## Ragsdale Reservoirs AM1 Adequacy Review 1

**Re: Ragsdale Reservoirs, Permit No. M-2020-007, Preliminary Adequacy Review**

RE: **Ragsdale Reservoirs, File No. M-2020-007, Amendment No. 1**

RE: CPW's Comments on the Ragsdale Reservoirs - File No. M-2020-007

Exhibit C- Mule Deer Migration Corridor indicated in striped red wine.

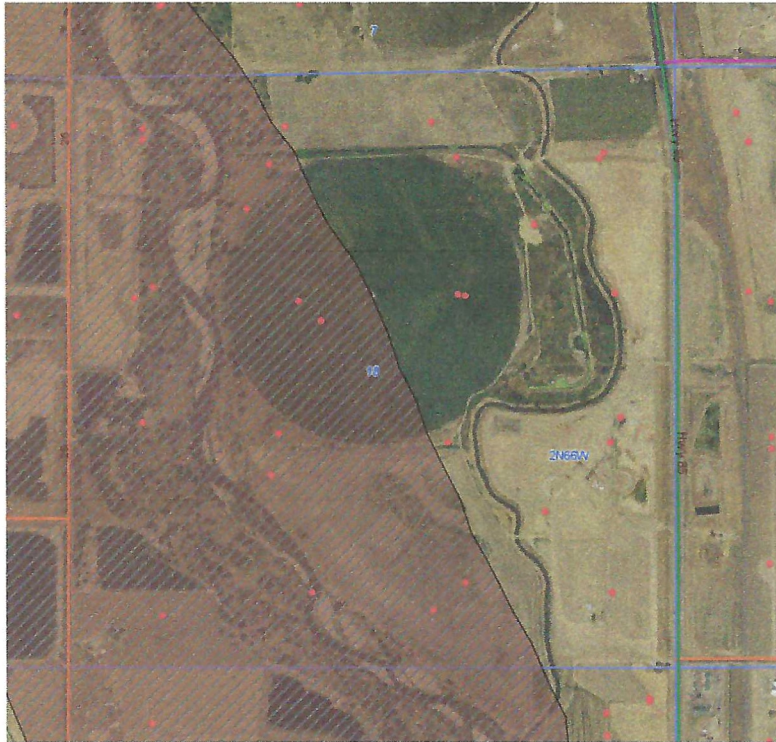
CPW also recommends avoiding the riparian corridor to the maximum extent possible to keep the migration corridor along the river as open as possible. In particular, a Mule Deer Migration Corridor occurs along the South Platte River Corridor on the western side of the project, as shown in Exhibit C.

Exhibit D- Bald Eagle Active Nest Site indicated in striped peach (½ mile buffer) and striped pink (¼ mile buffer).

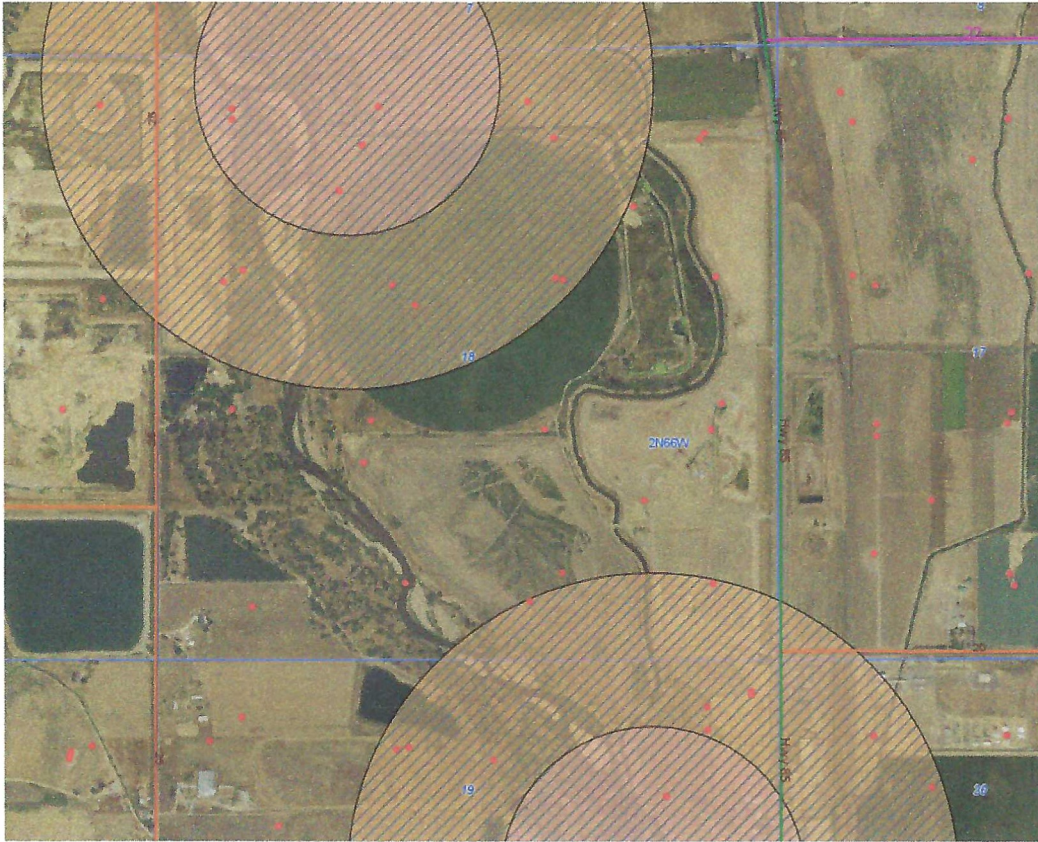
In particular, there are bald eagle active nest sites around the project site as shown in Exhibit D. CPW recommends avoiding these areas when expanding the project footprint. We also recommend constructing the new conveyor belt outside of the Bald Eagle nesting period to reduce potential impacts to the nests.

Exhibit E- Bald Eagle Roost Site indicated in striped orange.

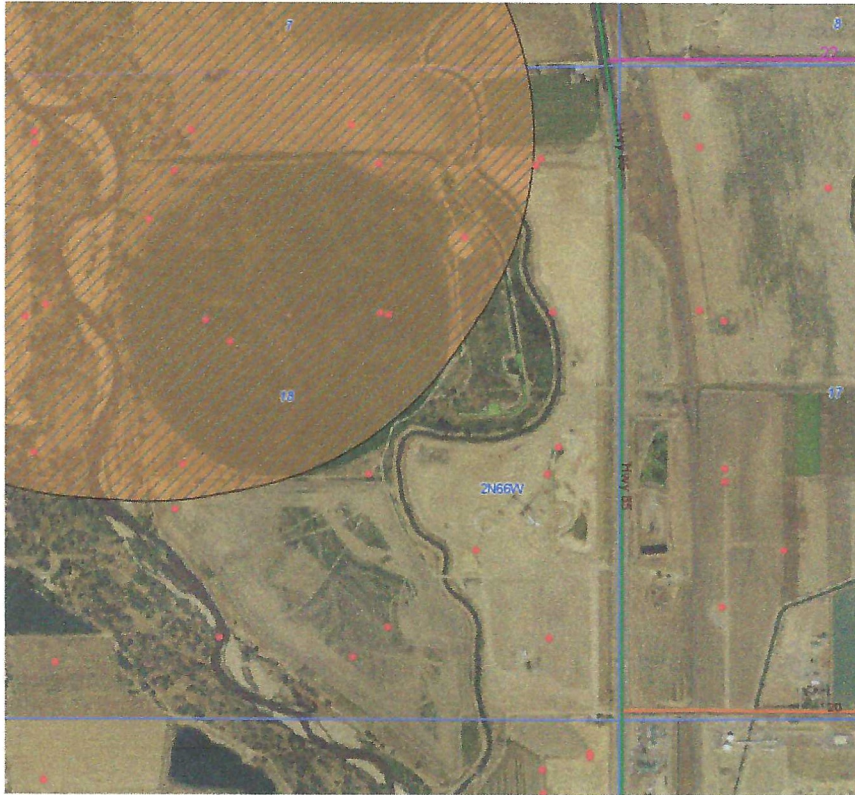
In particular, there is a bald eagle roost site along the South Platte River corridor as shown in Exhibit E.
